STAFF REPORT
(PRELIMINARY PLAT)

CASE NUMBER: SUB 2002-91 -- EVERGREEN THIRD ADDITION

STAFF REPORT
(FINAL PLAT, PRELIMINARY PLAT APPROVED 9/5/02)

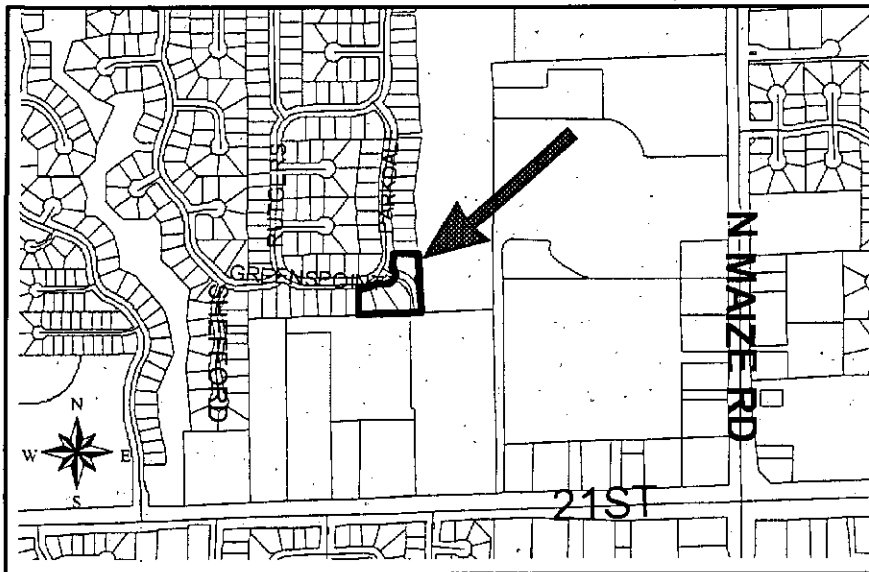
- E. The plat needs to denote the right-of-way width of Greenspoint and Parkdale.
- F. The third paragraph of the surveyor's text which states "Evergreen 3rd" needs to be revised to reference "Evergreen".
